REDBUD H&H HOMES

PLAN REVISIONS

REDBUD - GARAGE LEFT
H&H HOMES

TITLE
REVISION LOG

1ST FLOOR PLAN 'B'

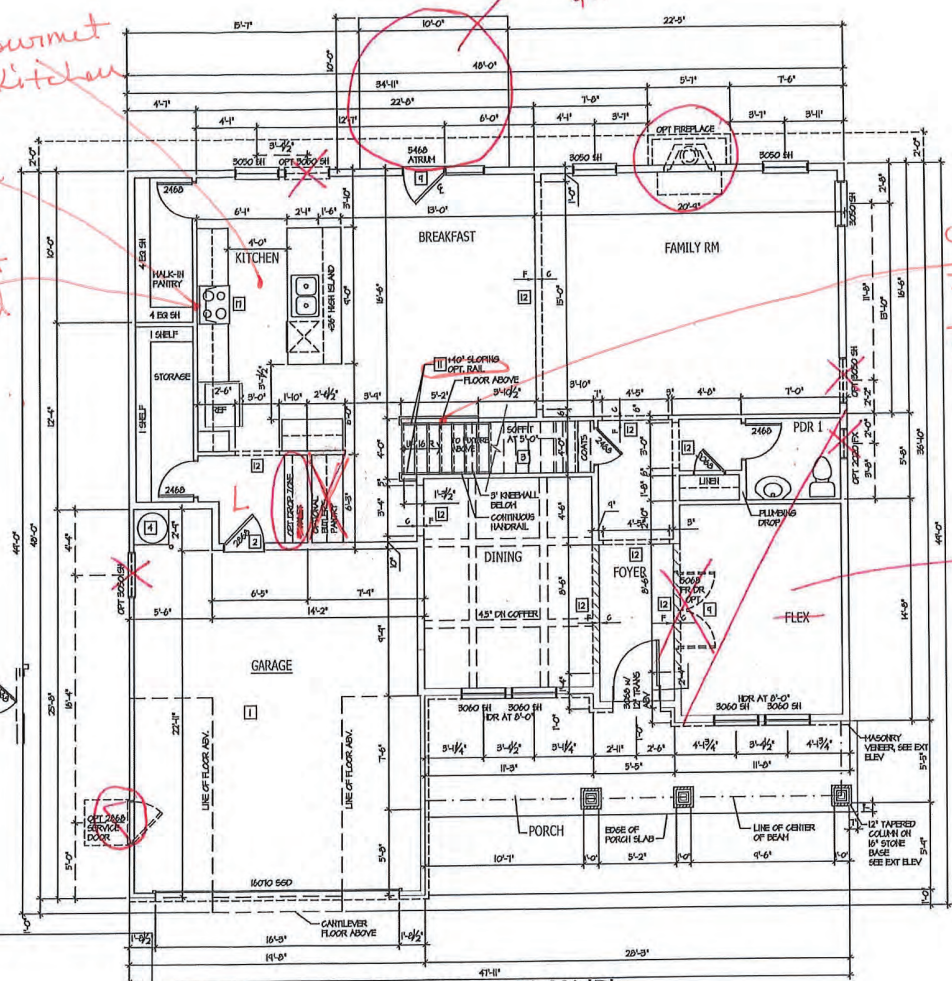
Gourmet Kitchen
gas line
vent hood

curb wall
Iron Pica
oak tread

see Bed #5
BAM #3
opt.

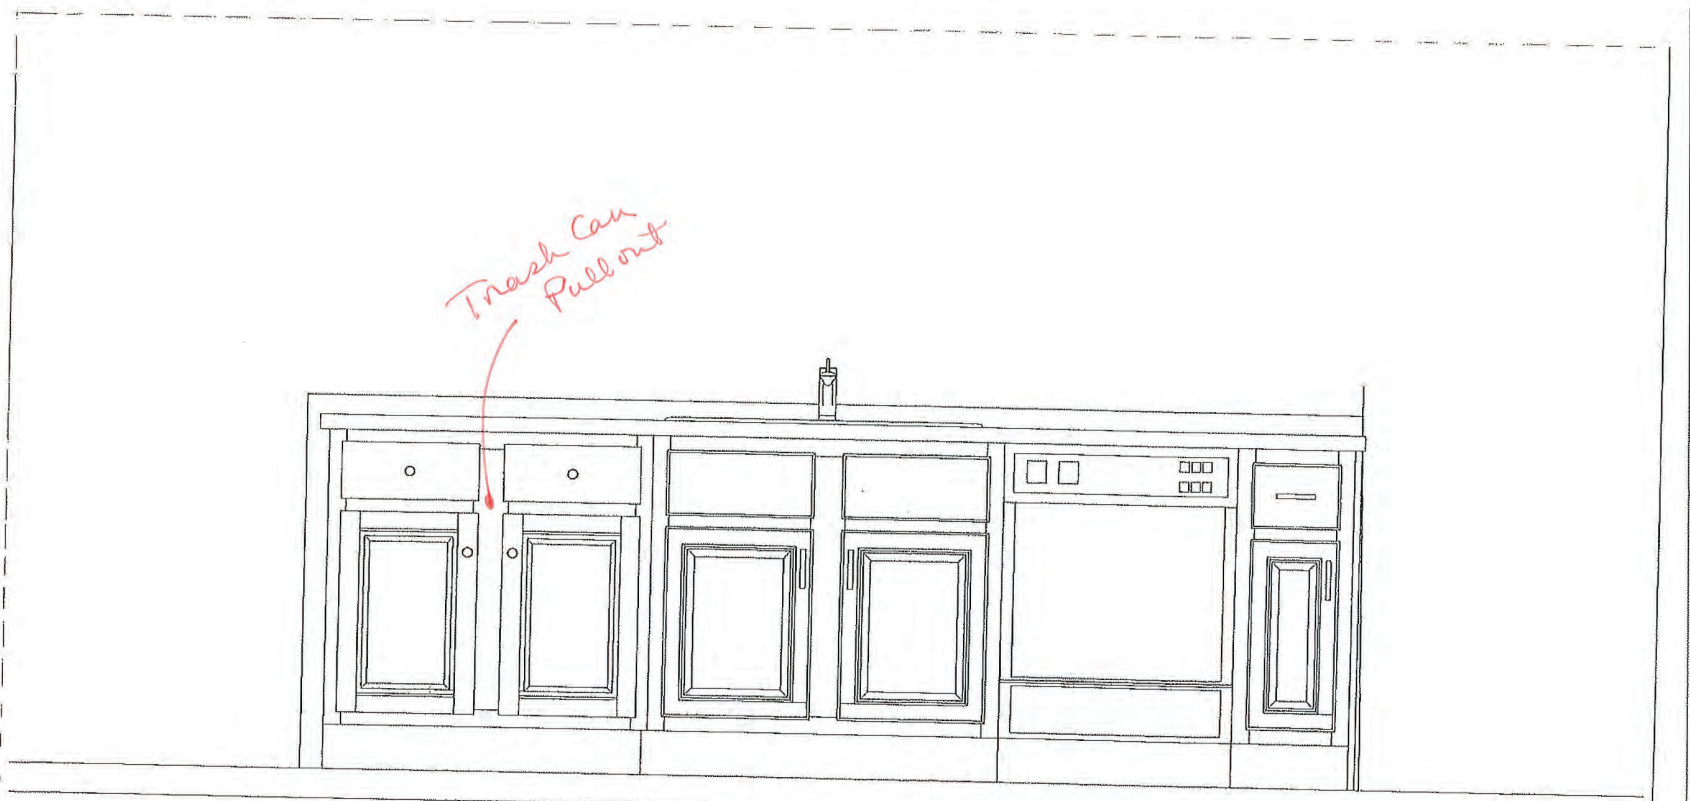
Single oven
microwave combo

vented
Hood

Roll Out
Shelves

*Trash Can
Pull out*

2ND FLOOR PLAN 'B'

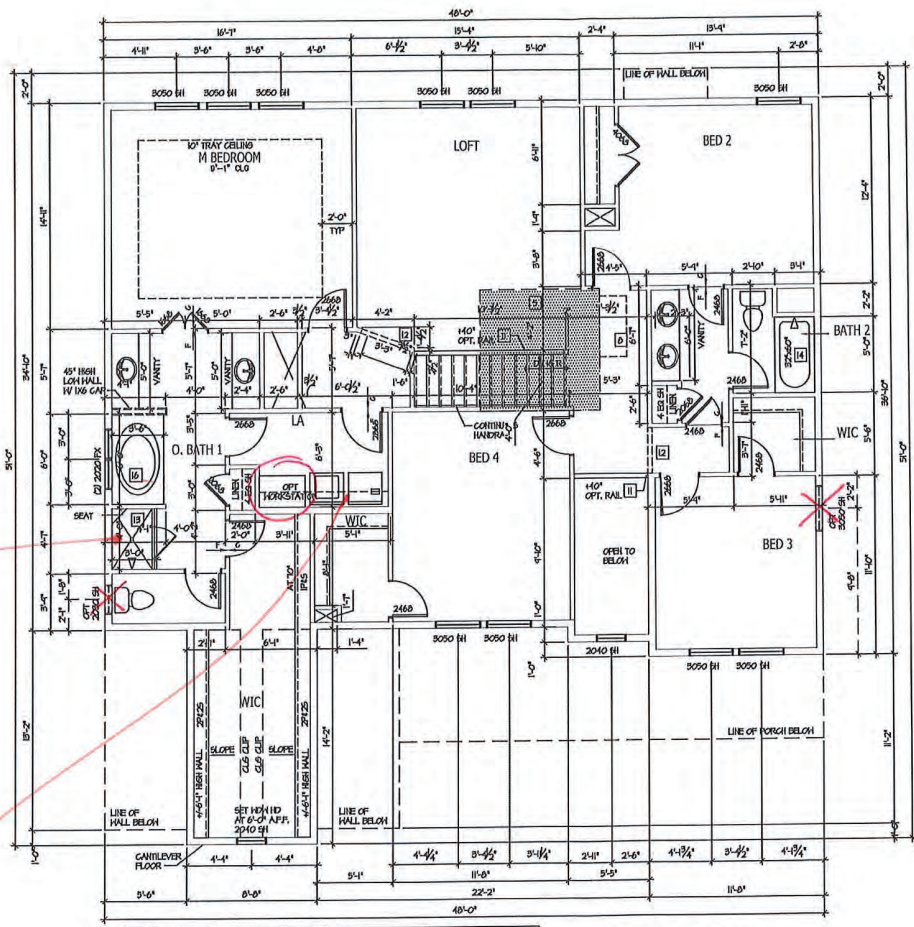
*Tile Owners
showers*

*Laundry
Cabinets*

OPT. BED 5/ BATH 3

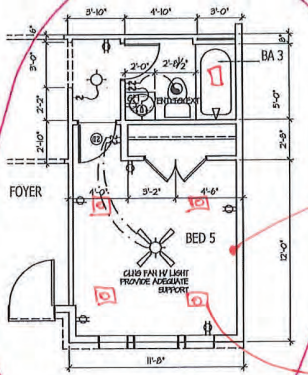
*1-Ø @ 60"
1-Ø just below at baseboard*

Accessed come w/ Downer

SECOND FLOOR FRAMING PLAN
ELEVATION A

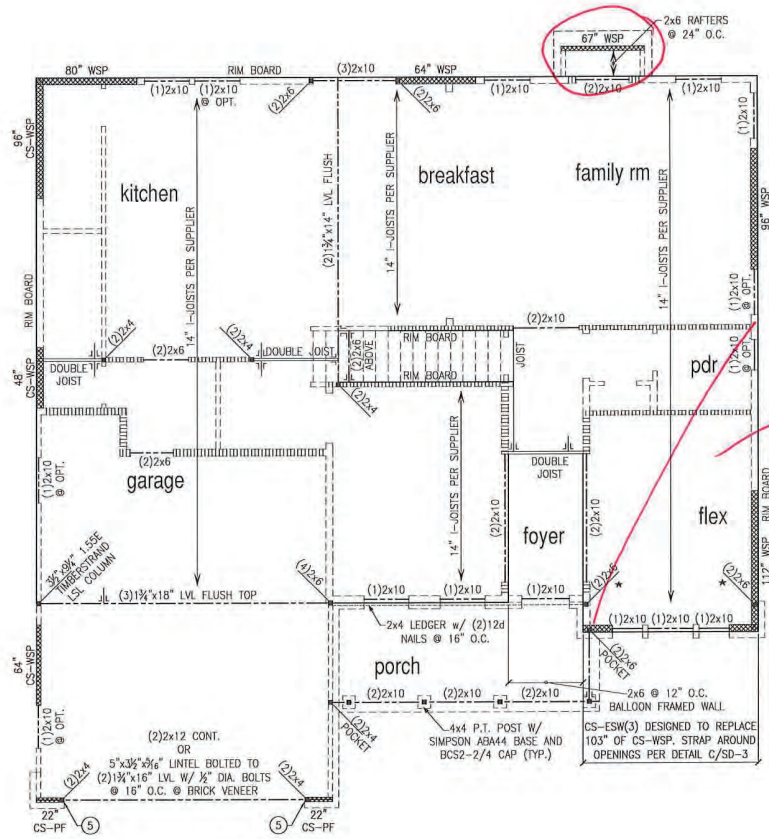
*Bed # 5 / Bath # 3
opt.*
